Hamilton City Council
Development Engineering Unit

ACCEPTED ENGINEERING PLANS

19-30410-01-LUK - CHEDWORTH - AREAS L, U & K - STAGE 24 (GREENHILL PARK) ENGINEERING DESIGN

Number	RFI	Recommended Resolution	S&L Comment	Comment	HCC COMMENTS 11/04/2025	S&L Comment.	HCC Comments 24/04/2025	S&L comments	HCC Comments 05/05/2025	HCC Comments 07/05/20252	S&L comments 06/05/2025
Table 1 – General observation/recommendation	The overall level of detail in the documentation isn't considered to be of sufficient detail to support an EPA design.										
T1.1	Detailed calculations supporting the design are incomplete. Overall, there seems to be significant reliance on conceptual work undertaken by Beca to support the CDP. It is expected that all design calculations would need to be revised to support an EPA design.	Resolution of specific items are included in the tables below. However, it considered that the application should be supported by a more comprehensive stormwater design document – ideally a Water Impact Assessment (WIA) prepared for this stage of development.	The Beca reports utilised for this design: - Beca Infrastructure report 2016 - Beca WIA 2016 - Beca SW Design report, 2016 Wit

30410-01-S24-SW6

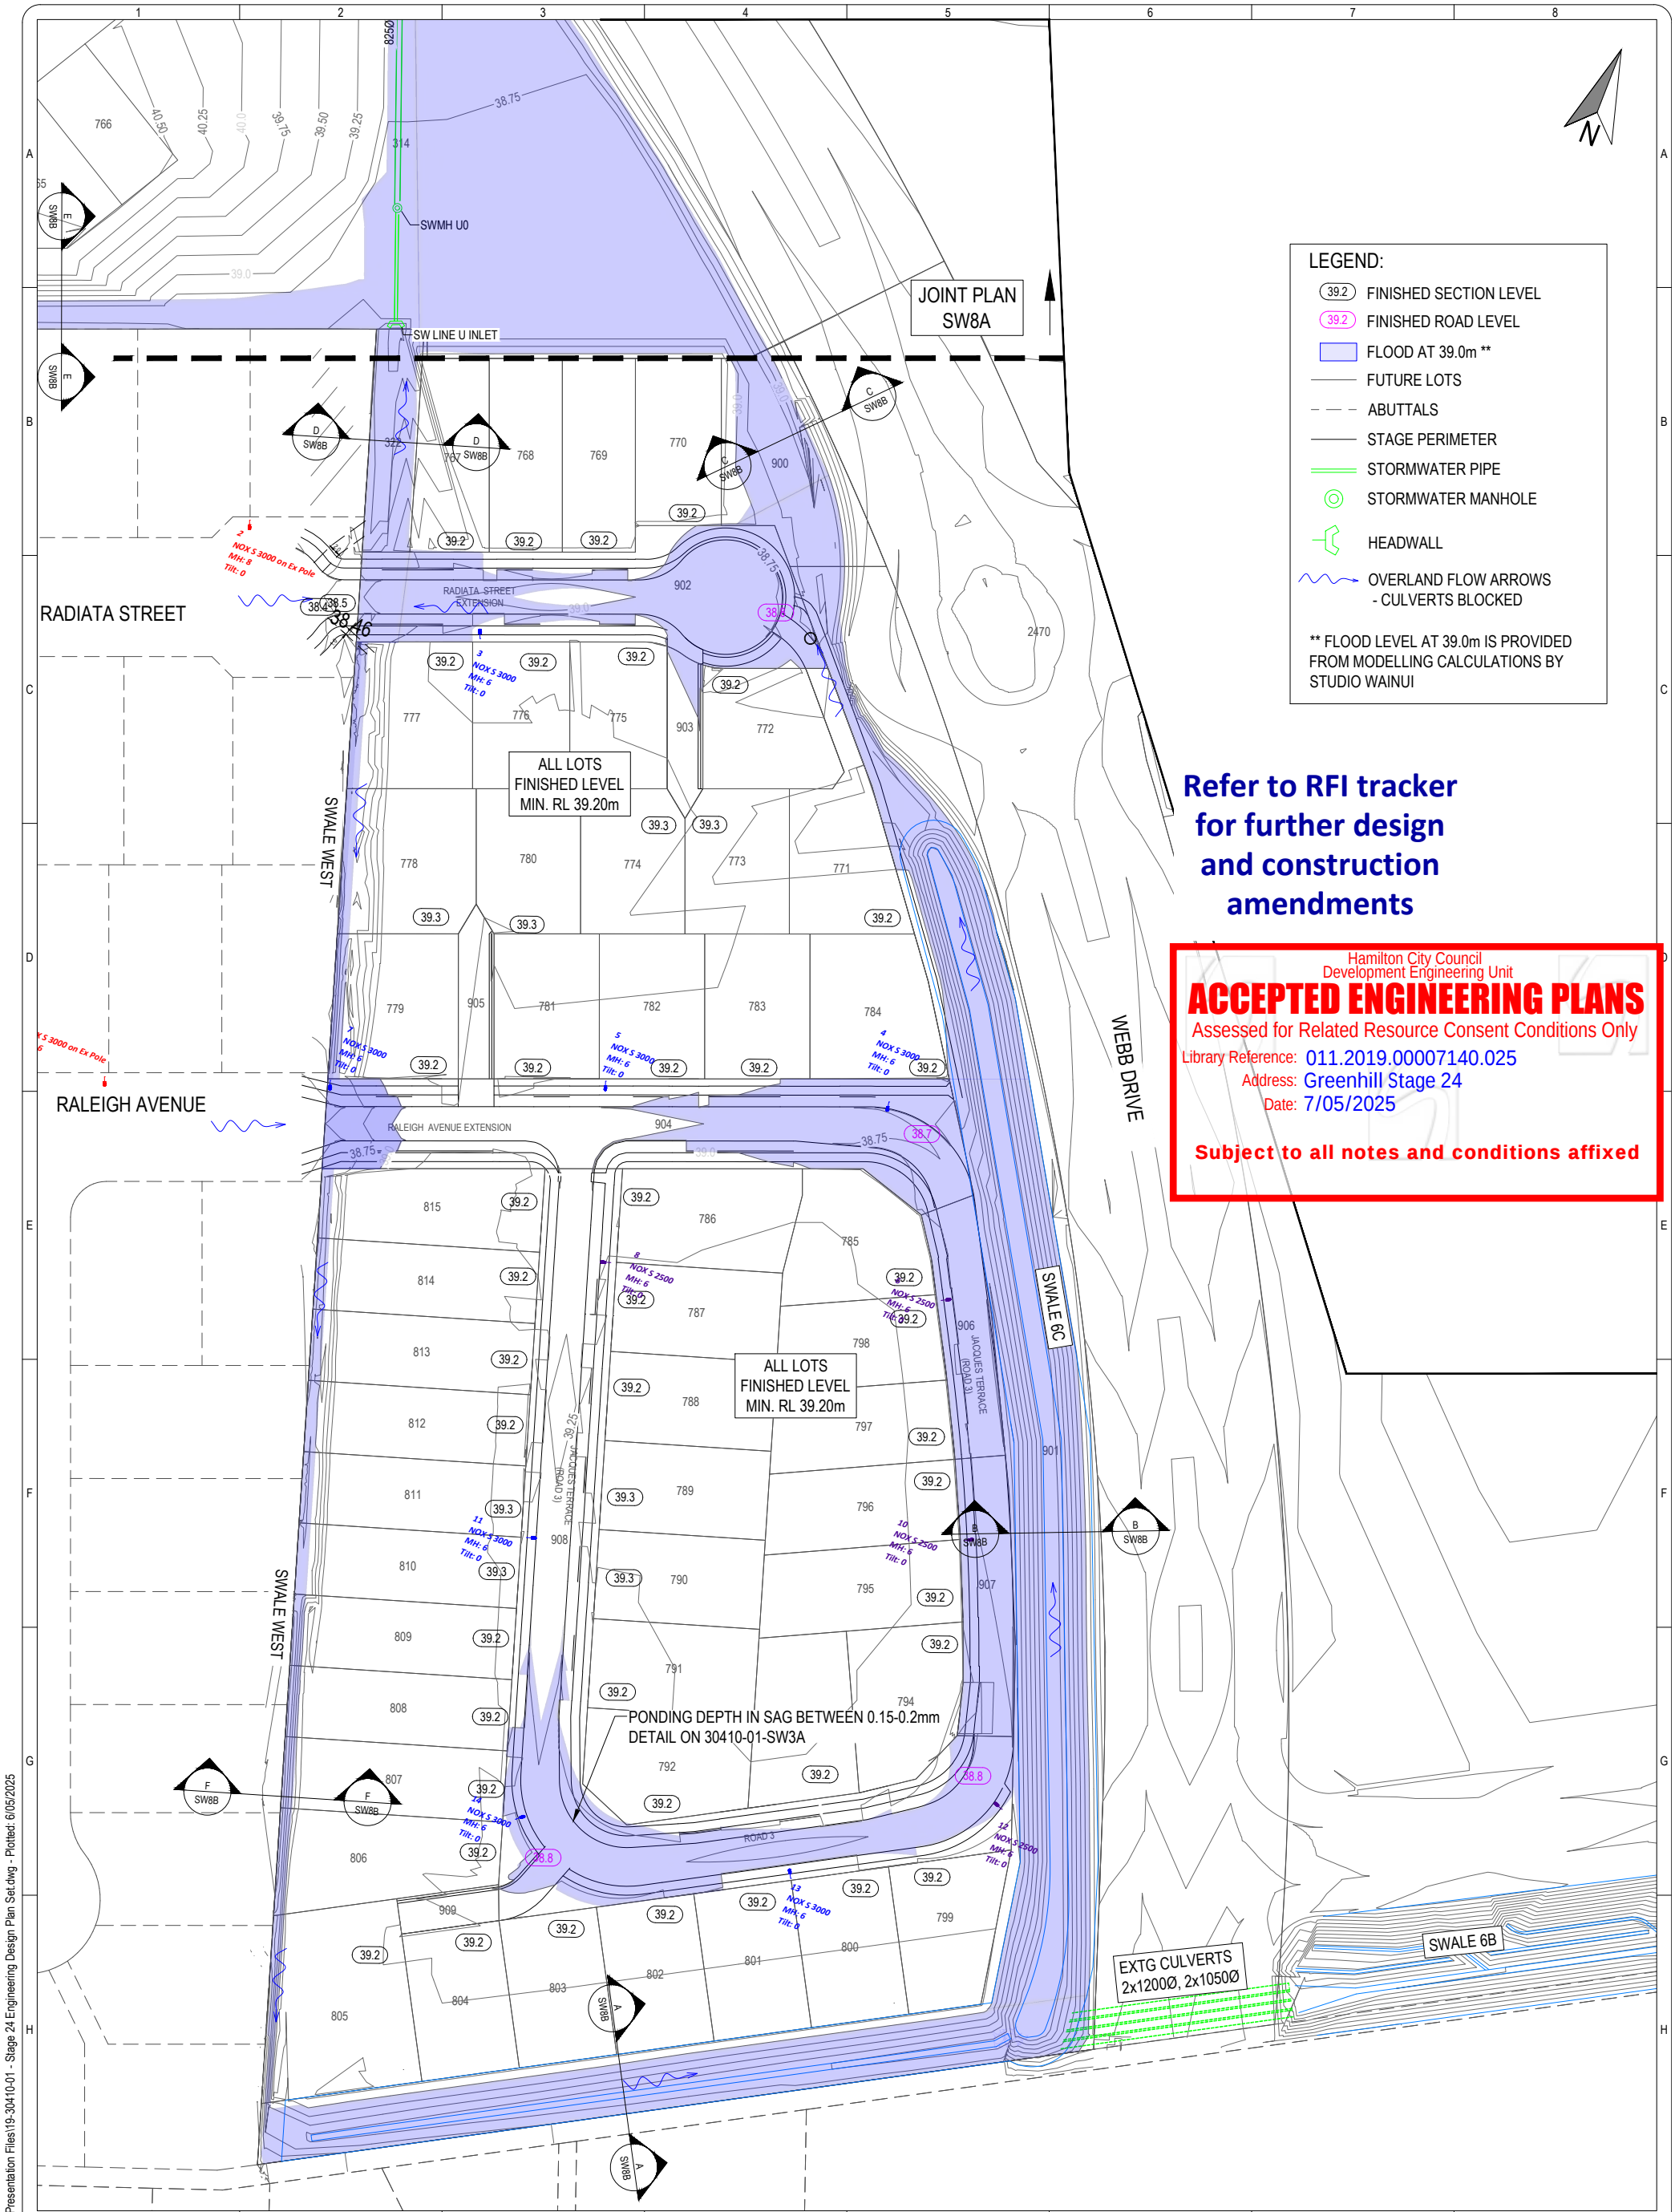
TS.16	Drawing S24-SW6 shows a bund on Lot 767 (chainage +020) – no top width or side slopes indicated. It is unclear to what extent this would affect this lot.	Update design of this drain/swale section to not require bunding.	There is no bund, this is a berm into the swale.	Complete	Noted, however swale slopes of 1:2 are not appropriate.	See section D-O on drawing SWB8.	Accepted			Closed by HCC on 24/04/2025.
TS.17	OLFP above 825mm pipe shown on drawing S24-SW6 shows batter slopes of 1:3, which is steeper than RITS allows for grassed swales.	Update swale design to be consistent with RITS.	To accommodate the OLFP we have kept the invert of the swale as wide as possible. The swale is shallow, so 1:3 should be maintainable.	Complete. Leave at 3:1 due to shallow swale.	Recommend post construction inspection required to confirm ability to maintain the swale with ride on mower. Remedials may be required.	Noted				Closed for EPA. We will undertake a post construction inspection required to confirm ability to maintain the swale with ride on mower. Remedials may be required.

CROSS SECTION E-E
AREA L SOUTH BOUNDARY SWALE

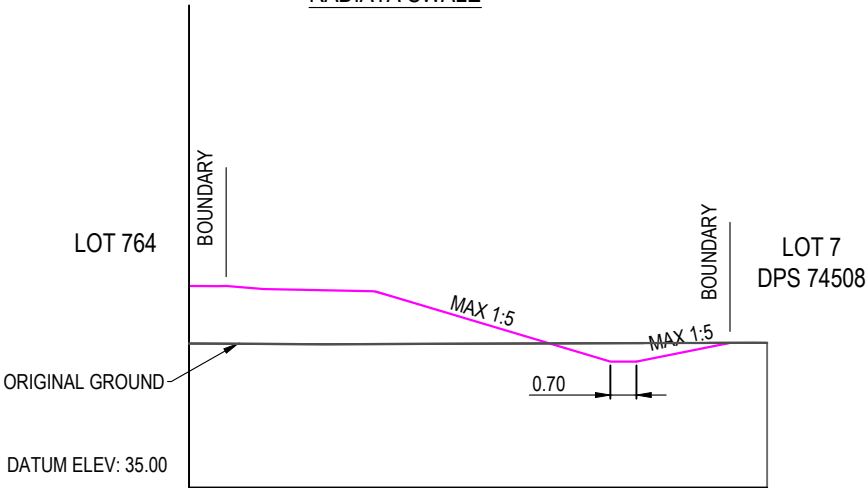
TS.22		Cross Section E-E - Notes show swale slopes up to 1:3.3. Can these batters be flattened to max 1:5 so they can be grassed. If not, prepare a plan showing areas that are steeper than 1:5.				Drawing SWB8 updated to show maximum gradient of 1:5	Accepted			Closed by HCC on 24/04/2025.
TS.23		Cross Section F-F - Require a long section of Swale West and cross sections at regular intervals to understand how this swale works and interfaces with the lots and neighbouring residential land				Cross sections of West swale are on drawings R19 & R20. Long section is on R18 and can also be viewed on SW11.	There are a number of cross sections that show steep side slopes to the channel. Particularly at the southern end CH0-90. This profile will be challenging to maintain and requires further consideration. Can the channel be widened to enable side slopes to be flattened to 1:3 max? Cross section F-F does not represent the actual design profile.	The swale is within the lots, and due to site constraints we are proposing a steeper gradient with no vegetation to maintain. Our methodology to achieve this is to shape the swale, cover with PVC then Coconut matting, please see the drawings R18, R19, R20 and SWB8.	Refer additional comments in email	Closed for EPA. PVC capping and coconut matting was rejected by HCC, however a 1:2 grassed slopes with a flat base was accepted via email on 6th May 2025.
